## **ALERT SERVICE BULLETIN**

**407-22-128**

**SUBJECT:** TAILBOOM ATTACHMENT HARDWARE AND FITTINGS, ONE-TIME TORQUE CHECK AND INSPECTION OF.

**Figure 1 - Tailboom Access Cover Removal/Installation**

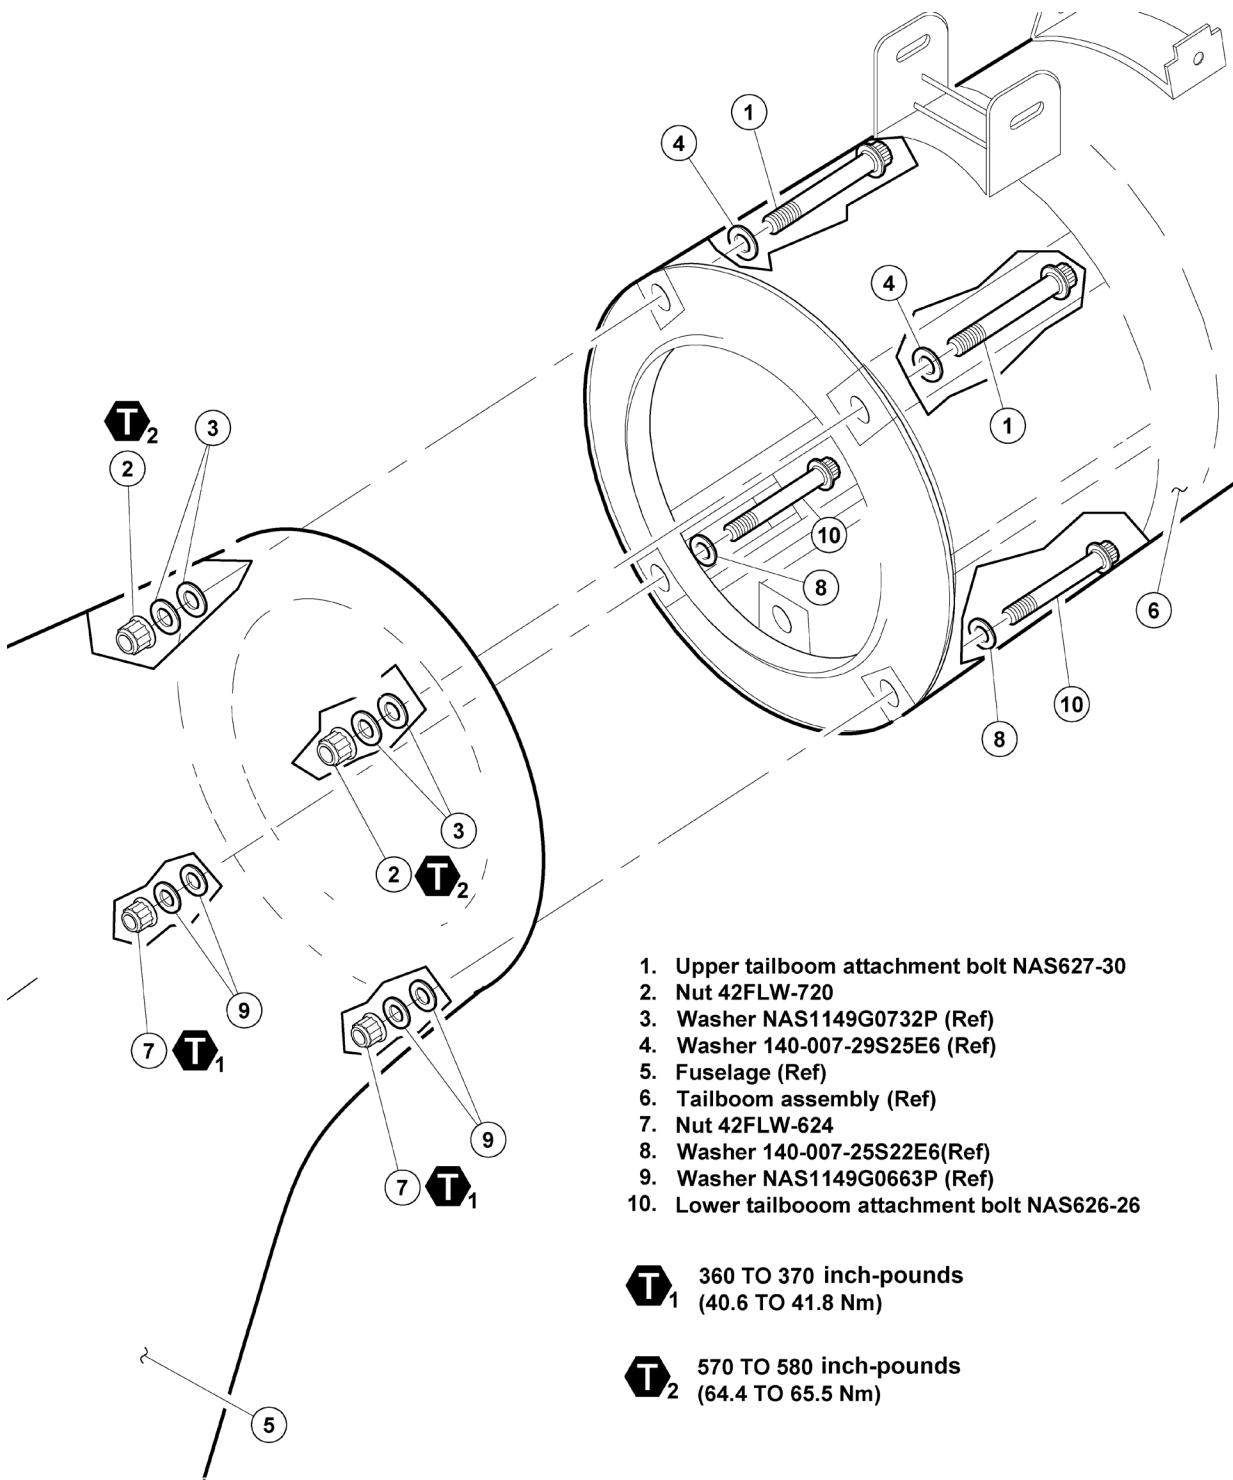
1. Prepare the helicopter for maintenance.
2. Remove tailboom access cover (1, Figure 1). Retain hardware for subsequent installation in later step.

- d. Record findings in **Annex A** of this bulletin.
6. Install tailboom access panel (1, Figure 1).
7. Return the completed **Annex A** to Product Support Engineering at [productsupport@bellflight.com](mailto:productsupport@bellflight.com) :
